MIDLAND PROJECT

MIDLAND DOCKET NO 50-329, 50-330

UNDERGROUND PIPING INFORMATION REQUESTED DURING APRIL 16, 1982 MEETING

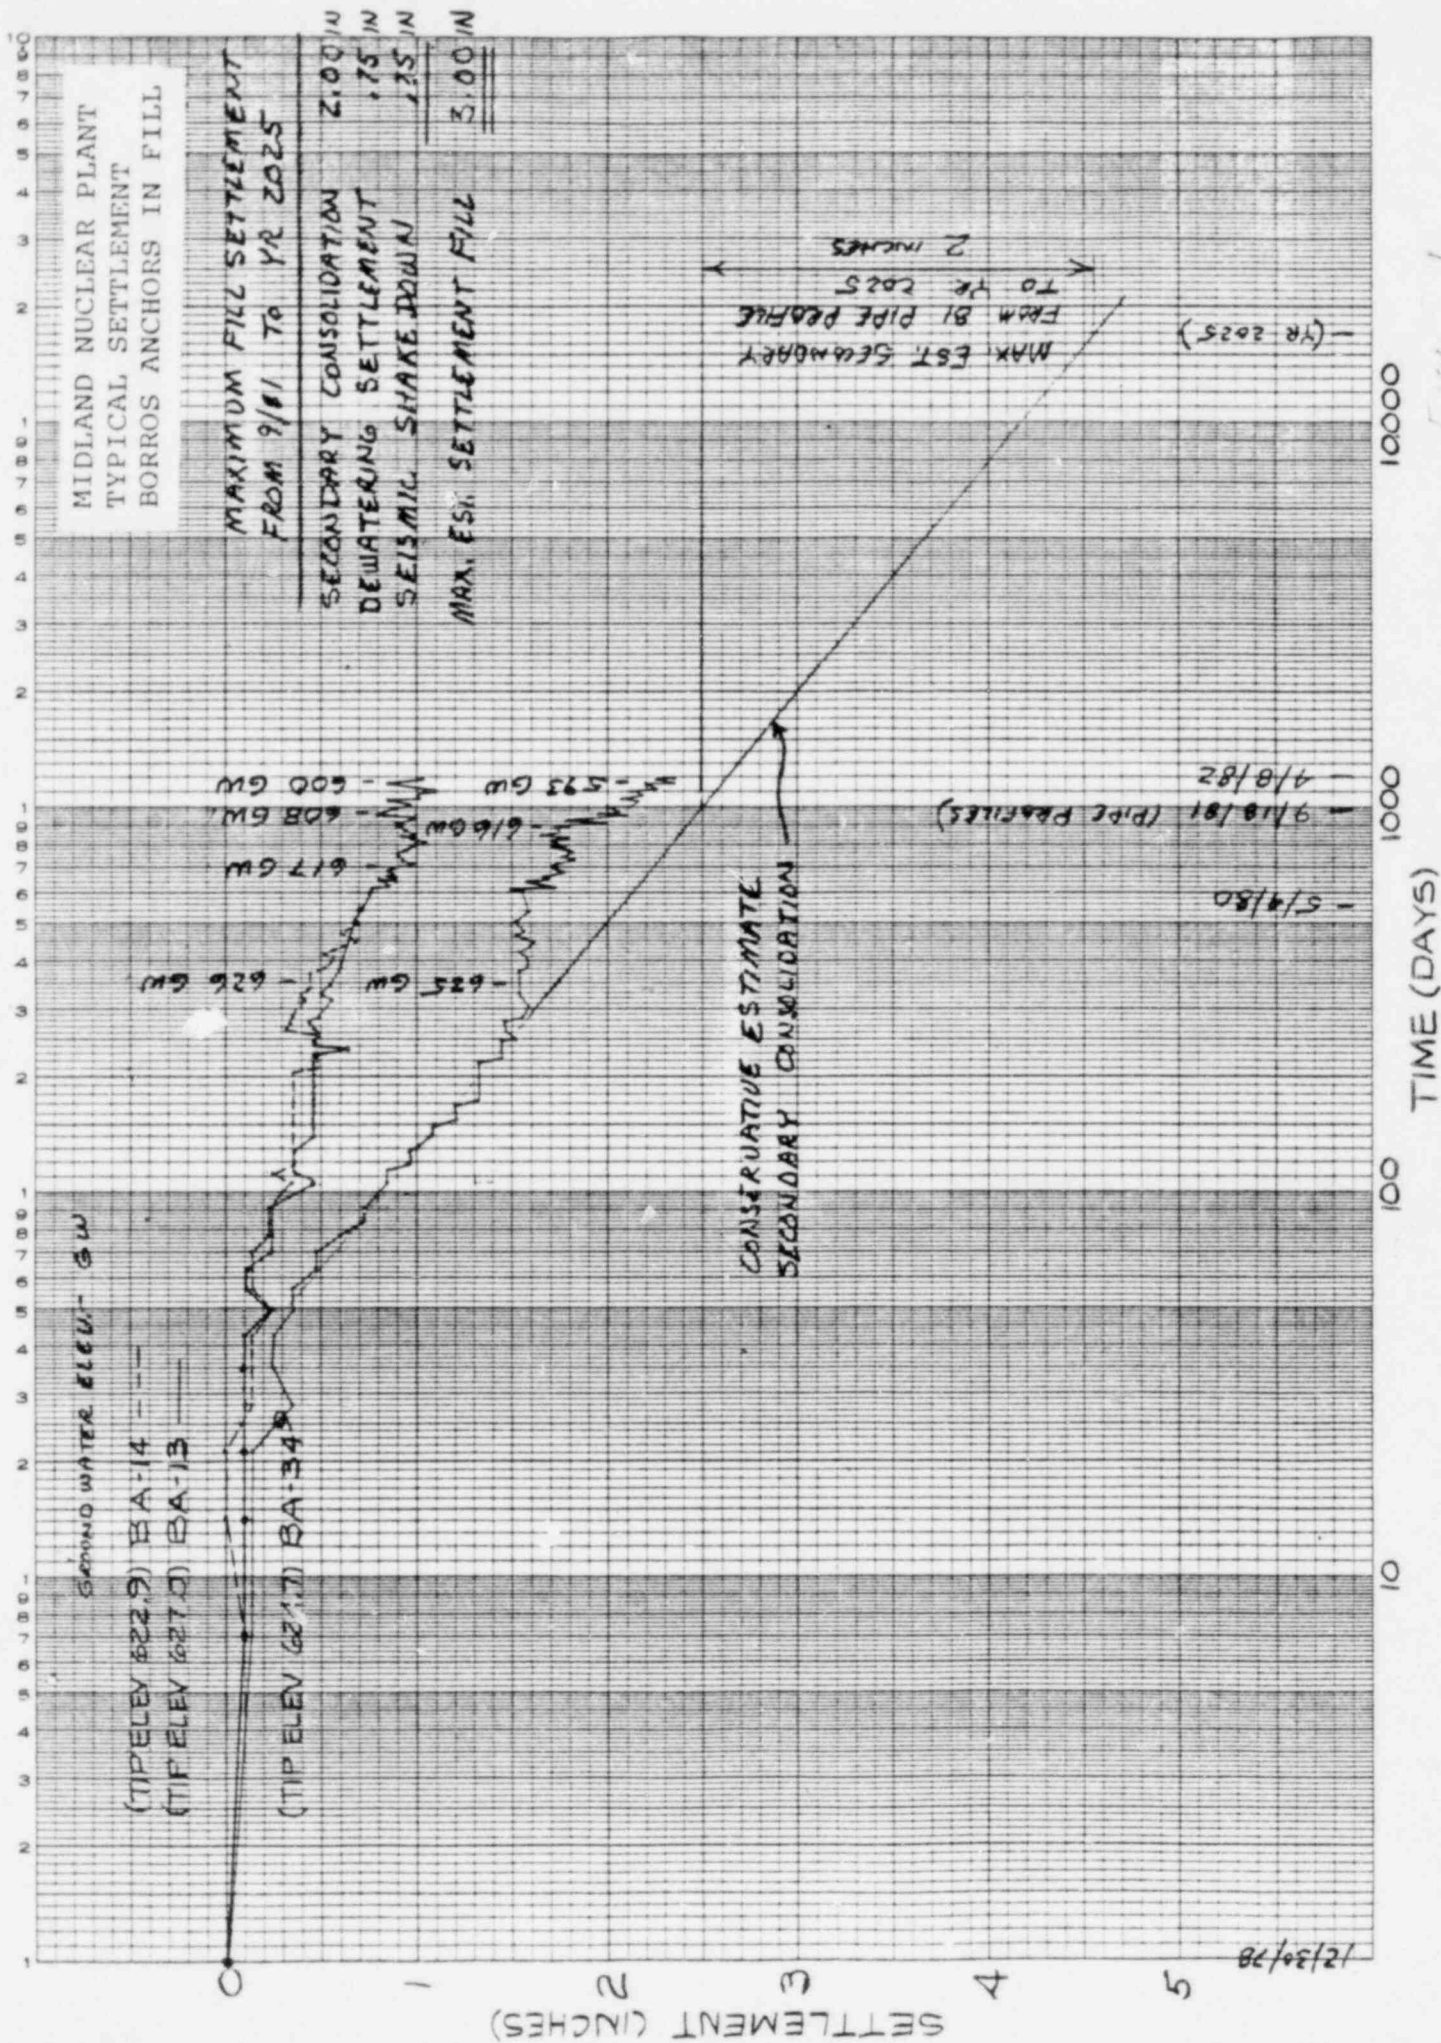
The NRC Geotechnical Branch requested information concerning soils and its relation to buried utilities. Enclosure 3 addresses the concerns expressed about the prediction of maximum future settlement for plant life (3.0 inches) and the isolated sand pocket near the diesel fuel tanks. A concern was also expressed about the soil properties used in estimating the soil forces required to deform condensate line (20-1HCD-169) into its present configuration. We have responded by separately providing the Structural Mechanics Associates calculations estimating the soil capacity at Midland.

To predict the maximum future settlement for buried utilities, settlement monitoring within the fill has been utilized in our analysis. There are nine (9) locations in the vicinity of buried utilities where Borros anchors have been installed and have not been influenced by surcharge loadings. Settlement readings for anchors that have been established at a depth of 7 feet to 12 feet below the surface were used in the analysis, since these depths are representative of the depth of most buried utilities. Soils conditions at the locations of the Borros anchors is also representative of the variable soil conditions encountered throughout the fill.

Borros anchors BA-13, BA-14, and BA-34 were installed in December 1978 and have over three years of data. Settlement plots for these anchors are shown on Figure 1.0. Borros anchors BA-100 through BA-106 were installed in September 1979 and have over two years of data. Settlement data from anchors BA-100 through BA-106 project less future settlement than shown for BA-34. The log of time versus settlement plots projected for most of these anchors predict on the order a maximum total 2.0 to 2.5 inches of additional settlement to occur over the next 40 years of buried utility life. Settlement projections for BA-34 are considered to provide a conservative estimate of the future maximum settlement expected beneath any buried utilities in the site fill. A total maximum future settlement during plant life has been estimated not to exceed 3 inches and includes settlement due to dewatering and seismic shakedown.
